**ITEM FOR ENVIRONMENTAL BOARD AGENDA**

**NAME & NUMBER OF PROJECT:** Tech Ridge  
C14-2008-0076

CUT-FILL EXHIBIT

**NAME & NUMBER OF PROJECT:** COLINA VISTA DUPLEX DEVELOPMENT  
SP-06-0411C(R1)

CUT-FILL EXHIBIT

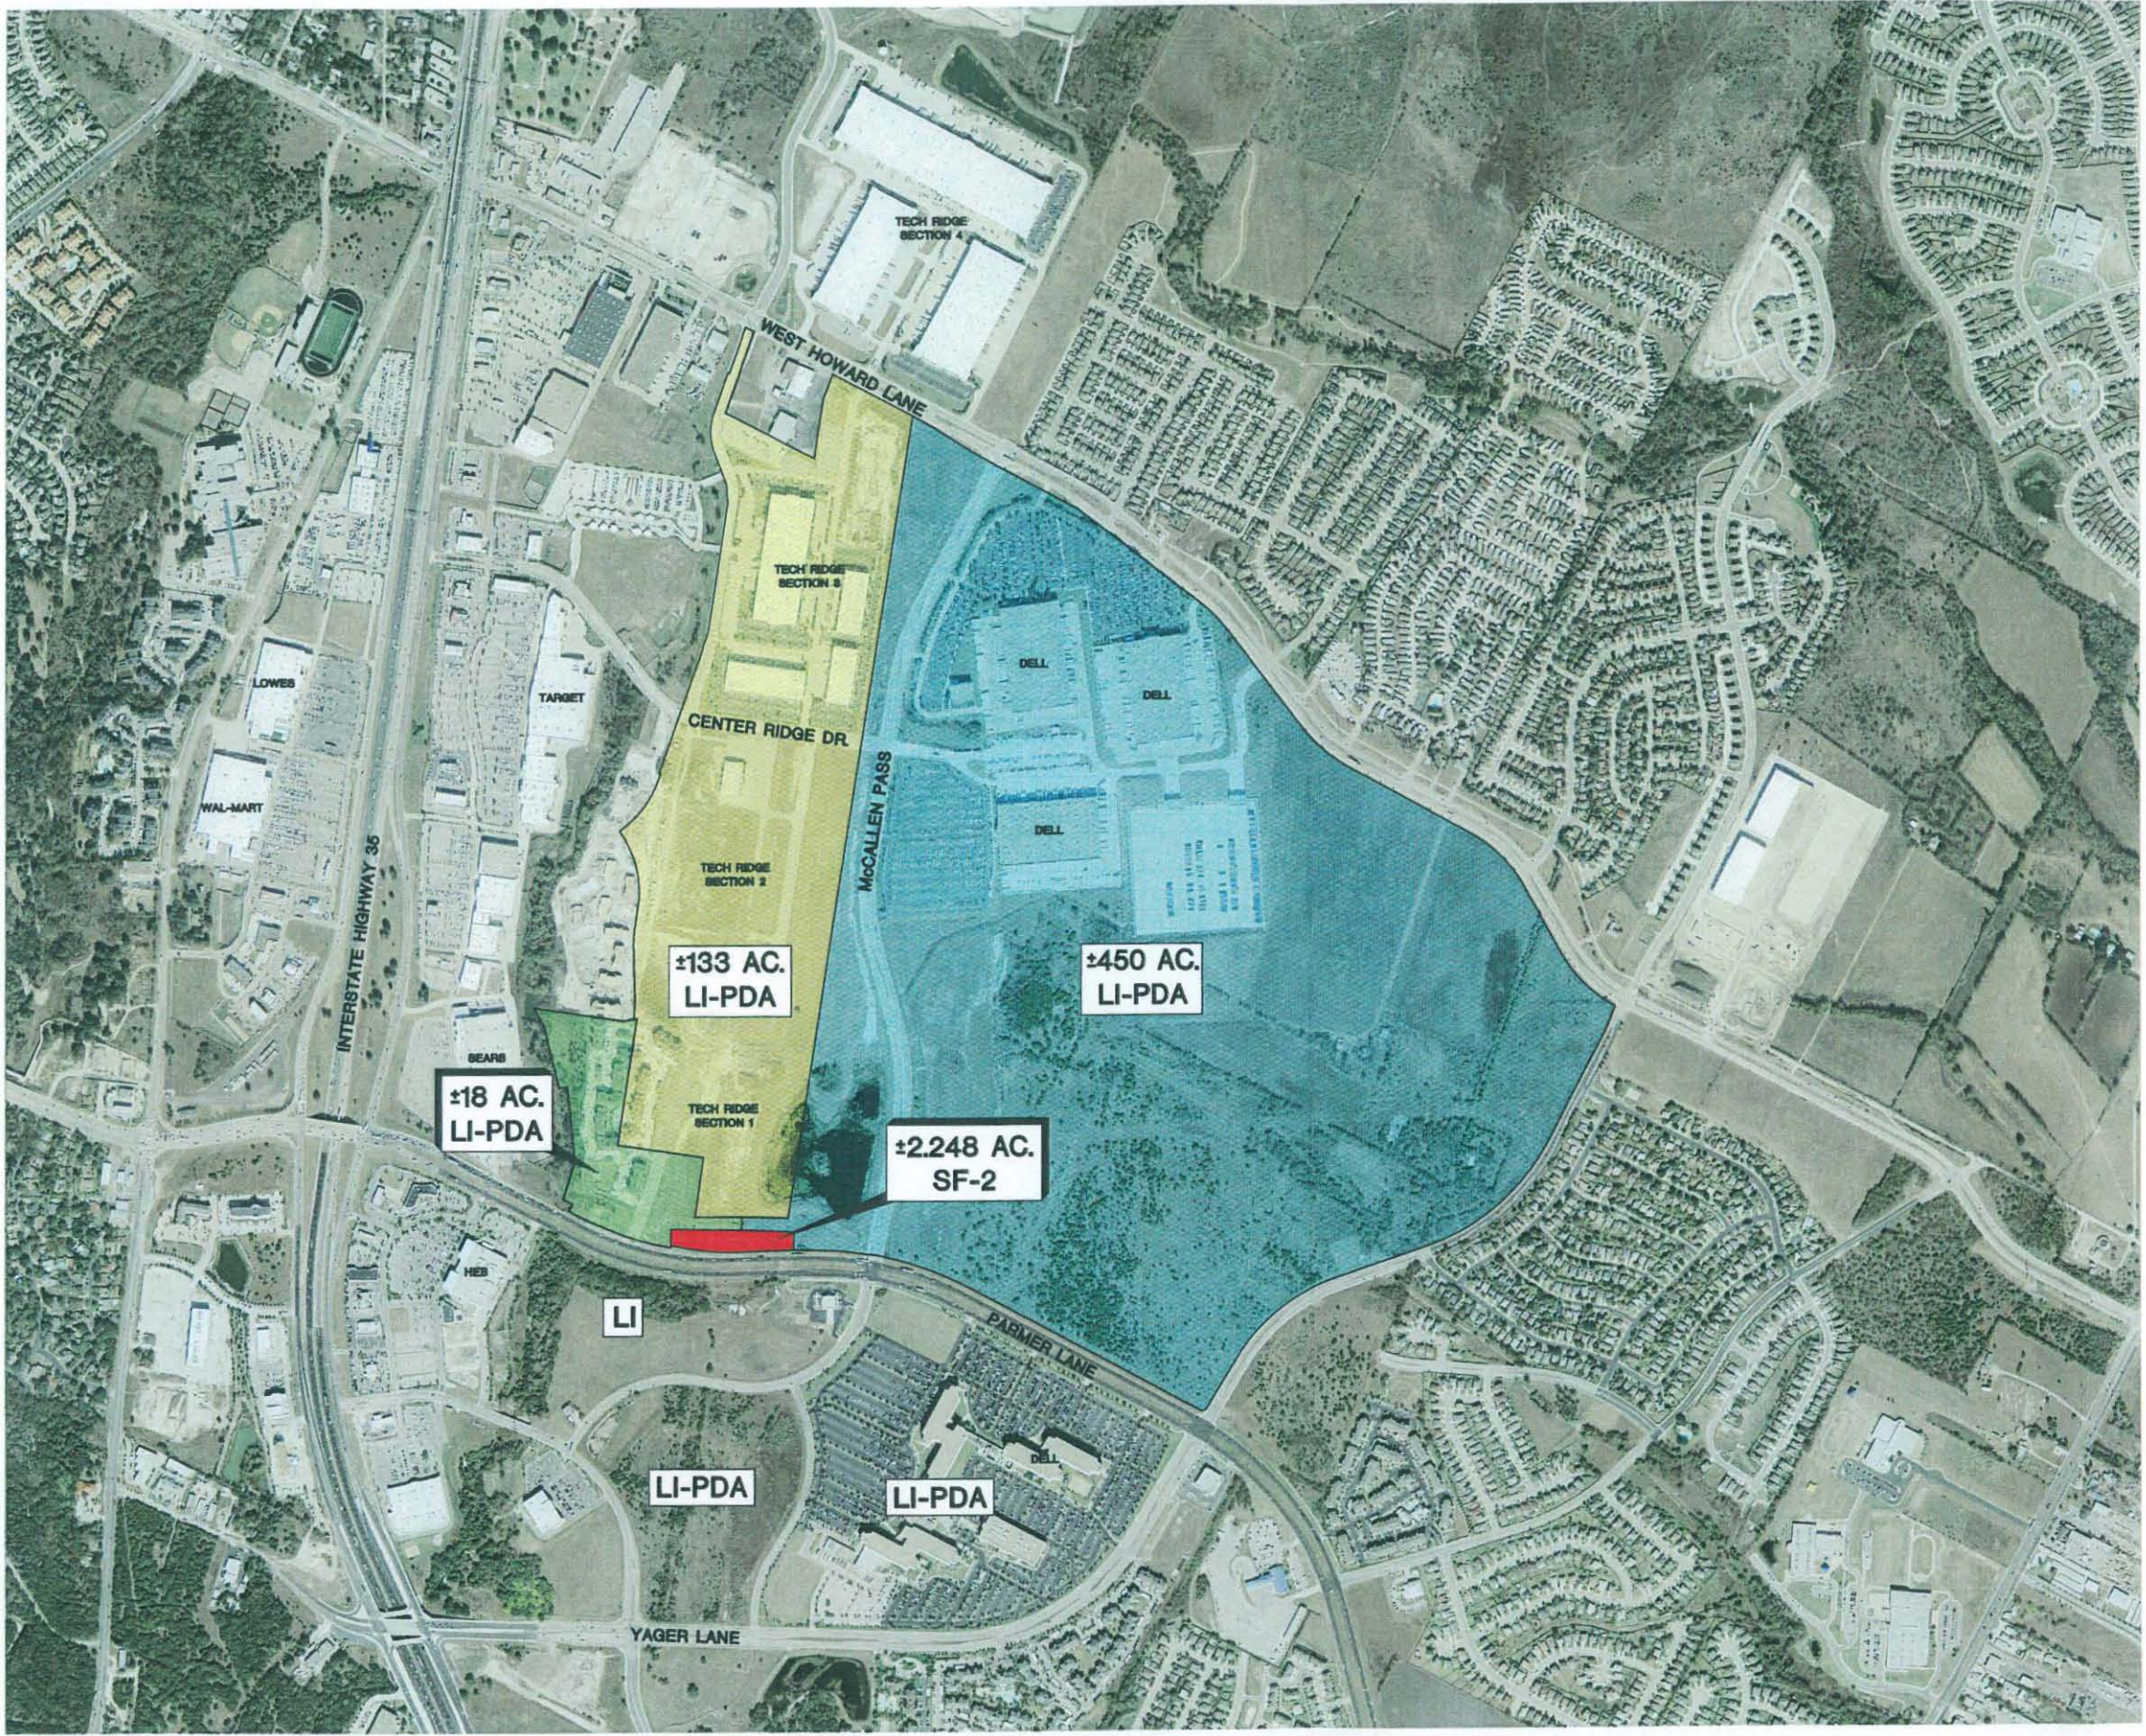
The Applicant is requesting an exemption to allow the Director of the Watershed Protection and Development Review Department to administratively grant an exception to allow fill up to 12 feet (LDC Section 25-8-342) during the site plan review process. The Subject Property will be incorporated into a unified development with the adjacent properties located to the north. Proposed under the unified development, the on-site flows from the Subject Property will be conveyed to the stormsewer system located on adjacent property owned by the Applicant; then those flows will be diverted to the regional wet pond. However, for the site to utilize the regional wet pond, 12 feet of fill is required: approximately 11 feet above the lowest elevation plus one additional foot of fill to allow positive drainage for the Subject Property and freeboard for the pond. No fill activities are proposed within the CWQZ located on the Subject Property nor are fill activities proposed within the Wetland CEF setback as established by ERM.

Since the Subject Property is at a lower elevation than the regional wet pond and also at a lower elevation than the adjacent tracts located to the north, a smaller water quality pond would be designed exclusively for, and located on, the Subject Property if the Applicant's exemption request for fill up to 12 feet is not granted. The existing regional wet pond provides superior water quality via a higher reduction in total suspended solids and chemicals than an alternative pond type (i.e., sedimentation / filtration, etc) that would be constructed on the Subject Property without the exemption for fill up to 12 feet. Therefore, the requested exemption provides a better opportunity to prevent harmful environmental consequences because it will allow the existing regional wet pond to be utilized for the Subject Property.

Staff from the Watershed Protection and Development Review Department have worked with the Applicant to provide benefits in site development as support for the proposed exception:

- The existing wet pond has a higher reduction in total suspended solids and chemicals than other alternative pond types (i.e., sedimentation/filtration, etc) typically used for a small drainage basin providing for improved surface and ground water quality;
- The proposed design will incorporate a visually appealing (masonry/stacked masonry-type) wall that will help structurally secure the proposed fill while providing parking lot screening along Parmer Lane
